Bulletin Level: 2*

Subject: Drive Plate Failure

Models Affected: All Boost models

Figure 1

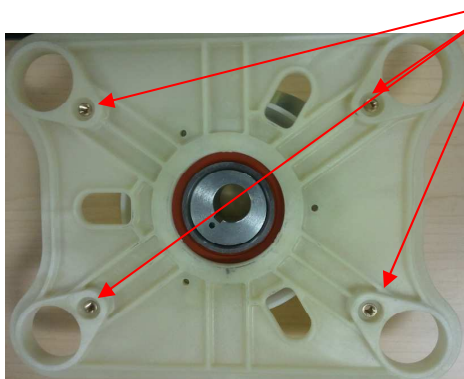
Issue: Drive plate part number 30663A fails prematurely

- 1) The Boost drive plate did not have sufficient structure to endure end-isolator failure.
- 2) The attachment screws where the drive plate ends at driver attachment may prematurely disengage due to a dimensional issue with the threaded portion of the drive plate.

- 1) Replace the drive plate part number 30663A with new rib reinforced plate 56381491 (Fig. 1).
- 2) Remove and discard buttonhead screws (56003825) and bushings (56380173) used to retain flex plate.
- 3) Make sure when attaching the drive plate to the pad driver that the portion of the drive plate that goes over the top of the isolator is pressed completely down onto the pad driver.
- 4) Replace screws and bushings with shoulder bolts, part number 56381989 (Qty 4, Fig. 2). Attach to inserts shown below and add Loctite 242 to the retaining shoulder bolts.
